ROLLING HILLS BOOSTER PUMP STATION SMALL SUBDIVISION DRAINAGE REPORT

(THE HILLS AT LORSON RANCH FILING NO. 1)

Add PCD File # PPR-21-075

DECEMBER 2021

Lorson Ranch Metro District will compile and submit to the county on a yearly basis the Drainage and bridge fees for the approved plats and shall show all credits they have received for the same yearly time frame.

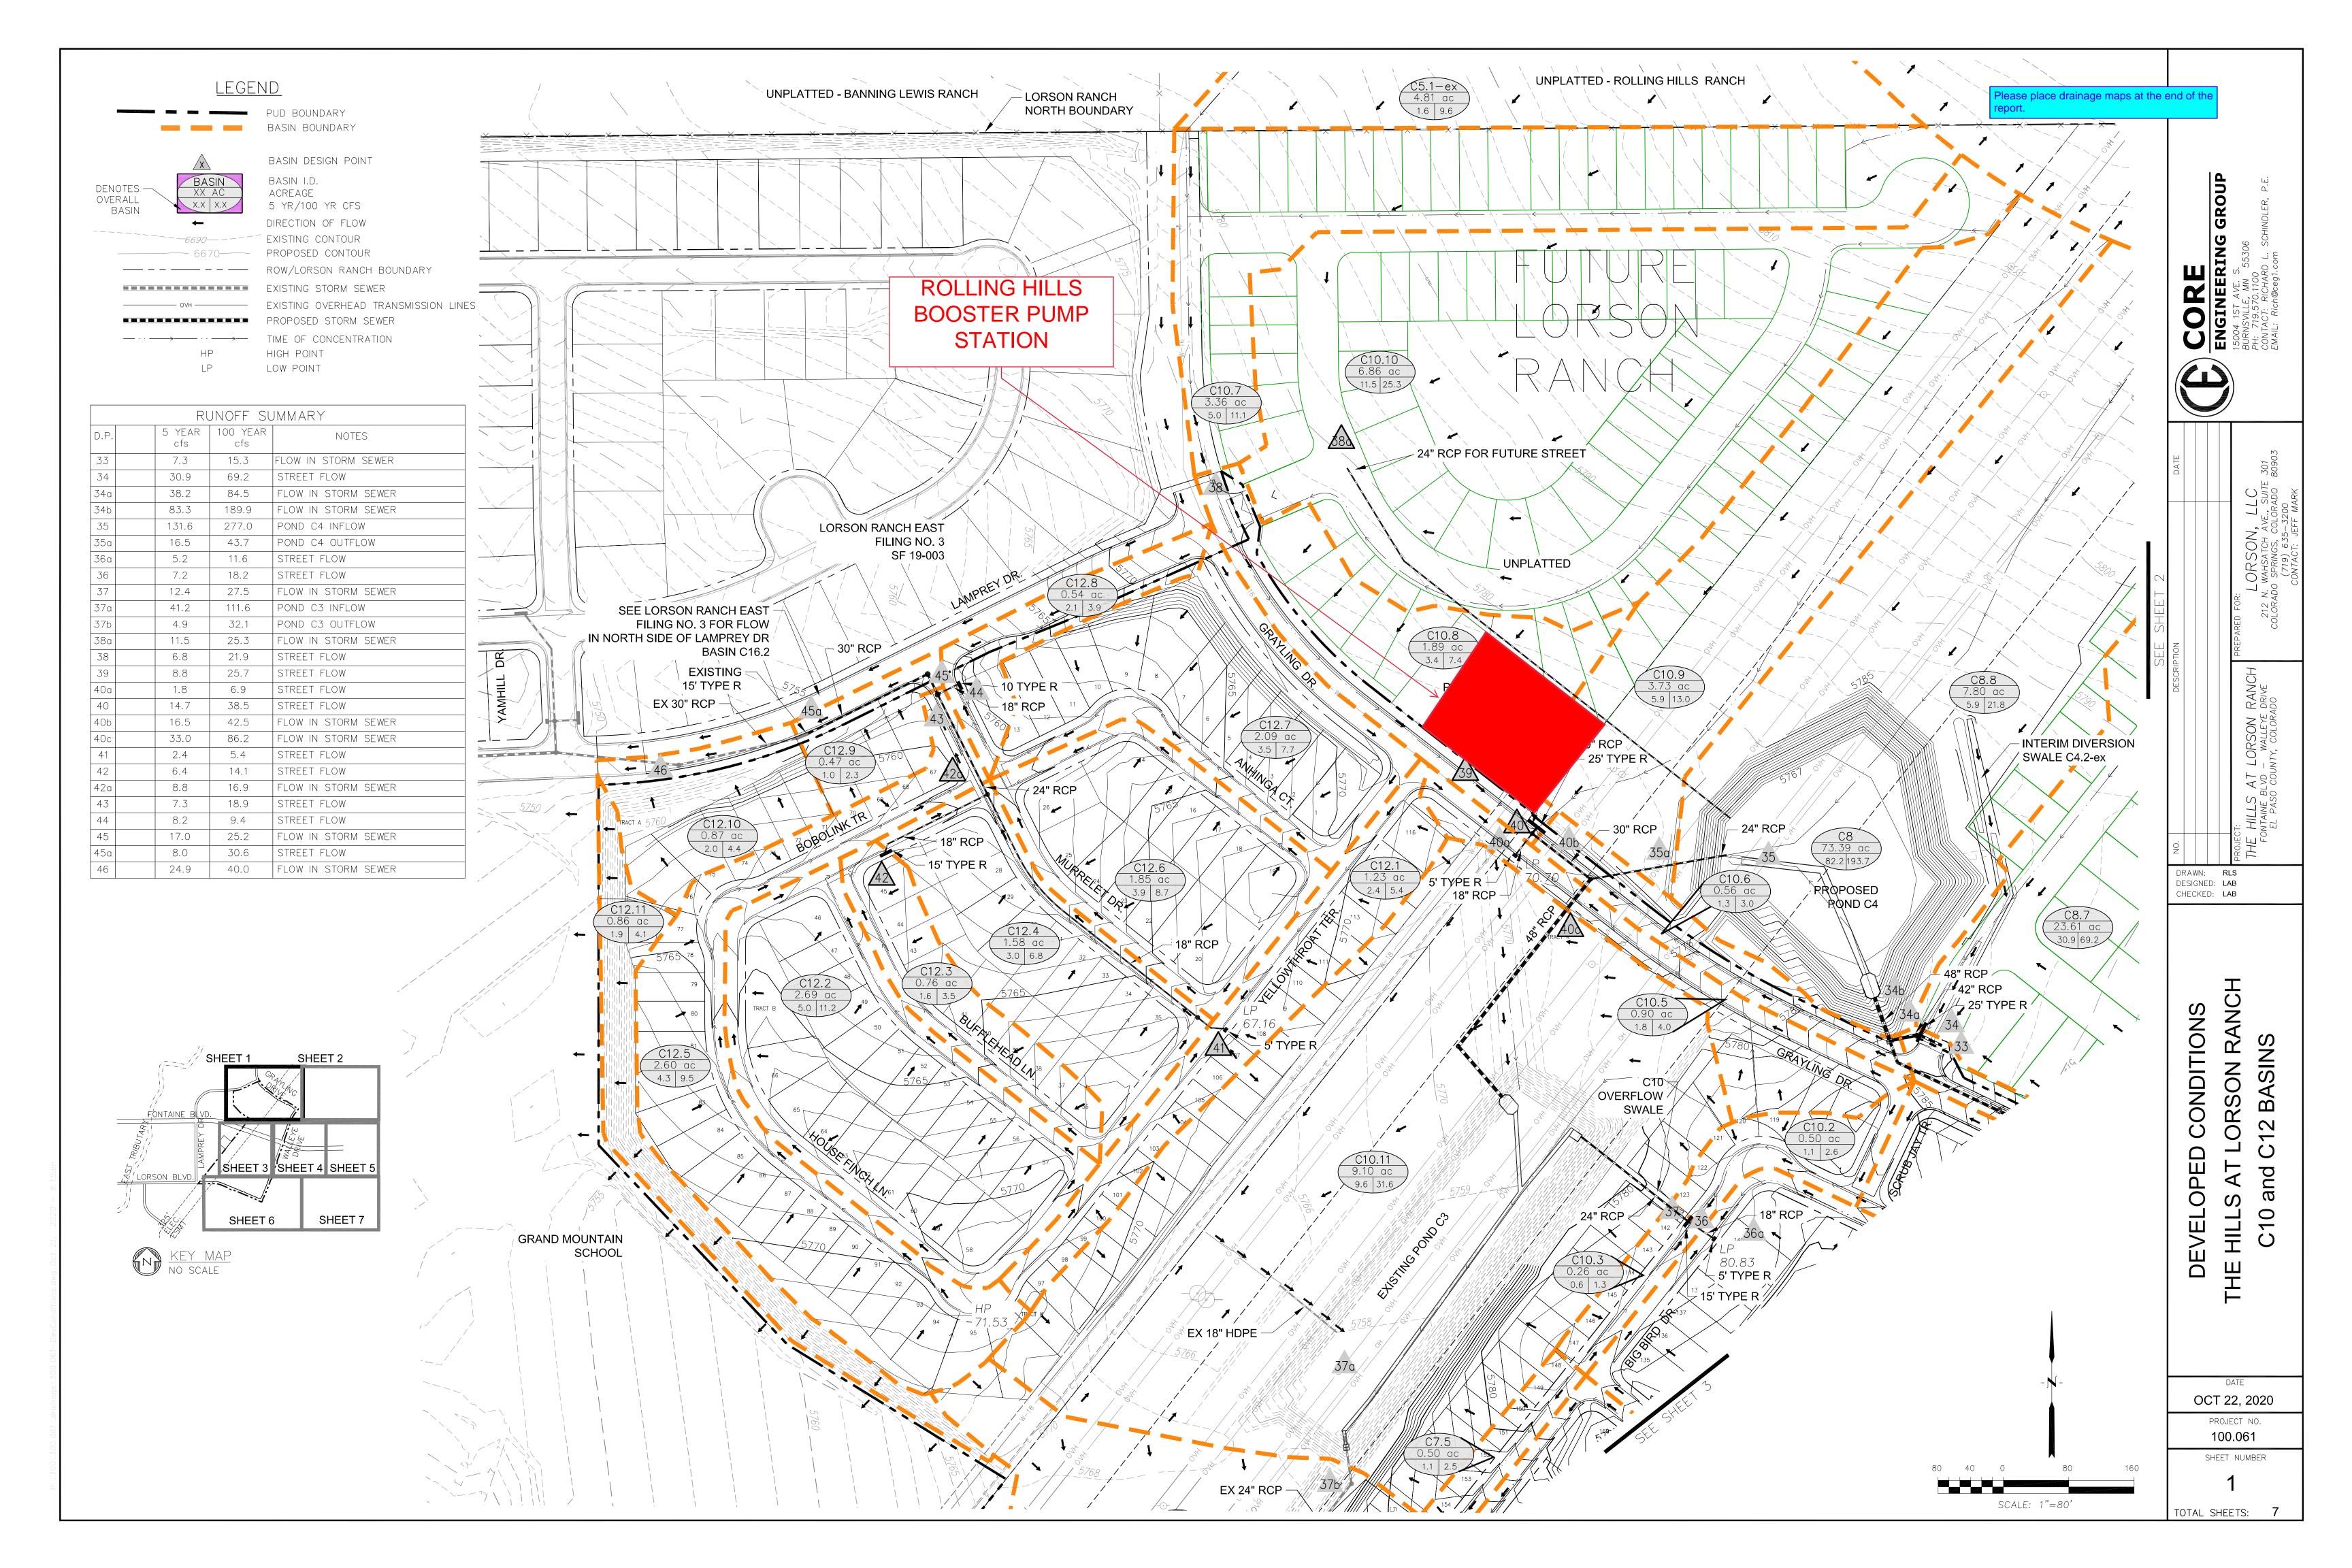
Drainage fee will be required when Skyline at Lorson Range Filing #1 is platted to include this area and tract. Please correct statement. This statement conflict with the FDR and Letter of Intent which states that Drainage Basin Fees will be paid.
